Re: Florida Power & Light Company
Proposed Turkey Point Units 6 and 7
Docket Nos. 52-040 and 52-041
Response to NRC Request for Additional Information Letter No. 037
(eRAI 5896) SRP Section - 02.05.02 Vibratory Ground Motion

NRC RAI Letter No. PTN-RAI-LTR-037

SRP Section: 02.05.02 - Vibratory Ground Motion

NRC RAI Number: 02.05.02-7 (eRAI 5896)

Figure 1 - Seismicity Within the Cuba Areal Zone and the Northern Subzone Used to Assess Differences in Earthquake Rate on Site Hazard.

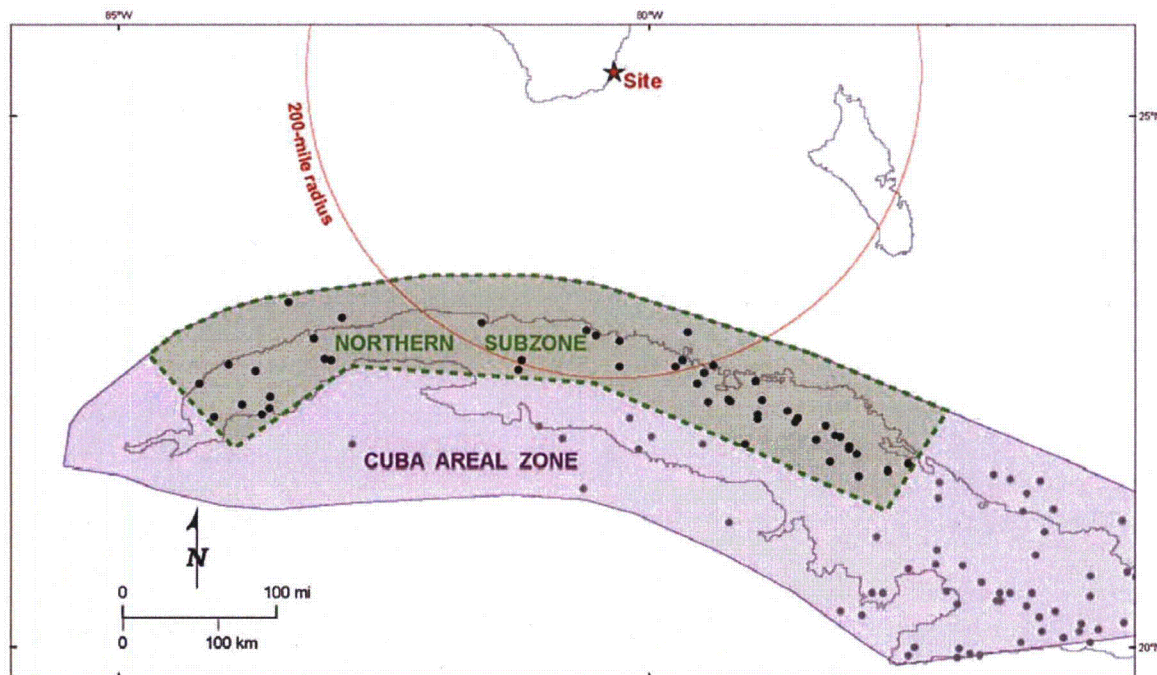
- c. A description of how well the seismic source model parameters represent the observed spatial patterns and concentrations of seismicity. Is a uniform seismic source zone justified considering FSAR Figure 2.5.1-267, which shows prominent clusters of seismicity? Discuss evidence, if any, that frequency-magnitude behavior is different for the subset of earthquakes concentrated in western and northern Cuba than for the entire zone.

c) A description of how well the seismic source model parameters represent the observed spatial patterns and concentrations of seismicity. Is a uniform seismic source zone justified considering FSAR Figure 2.5.1-267, which shows prominent clusters of seismicity? Discuss evidence, if any, that frequency-magnitude behavior is different for the subset of earthquakes concentrated in western and northern Cuba than for the entire zone.

The project Phase 2 earthquake catalog exhibits a non-uniform distribution of seismicity across Cuba, with higher concentrations of earthquakes occurring in the western, north-central, and southeastern portions of the island. To address the impact of different rates resulting from alternative zonation schemes within the Cuba areal source, a Northern Subzone zone encompassing the north-central and western seismicity was defined. This area of higher seismicity is used to illustrate the potential impact on hazard if different rates or zonation schemes were used to model the Cuba source. Recurrence statistics were computed for this subzone by calculating the annual rate of $M \geq 3$ earthquakes in the zone, and assuming that the previously calculated b-value for the Cuba areal source zone represents the most stable estimate. The annual rates of M 5 to 7.3 earthquakes from the two zones were then compared.

Maximum likelihood recurrence parameters were computed for the Cuba areal source zone, using the Weichert (1980) formulation, and the earthquakes filtered for completeness periods (Figures 1 and 3). The b-value for the Northern Subzone is assumed equivalent to that for the Cuba areal source zone, and the a-value is computed from the annual rate of $M \geq 3$ events in the subzone. The a-value, or the rate level parameter, has been normalized to the cumulative value per square kilometer per year, to permit a comparison normalized to a common area.
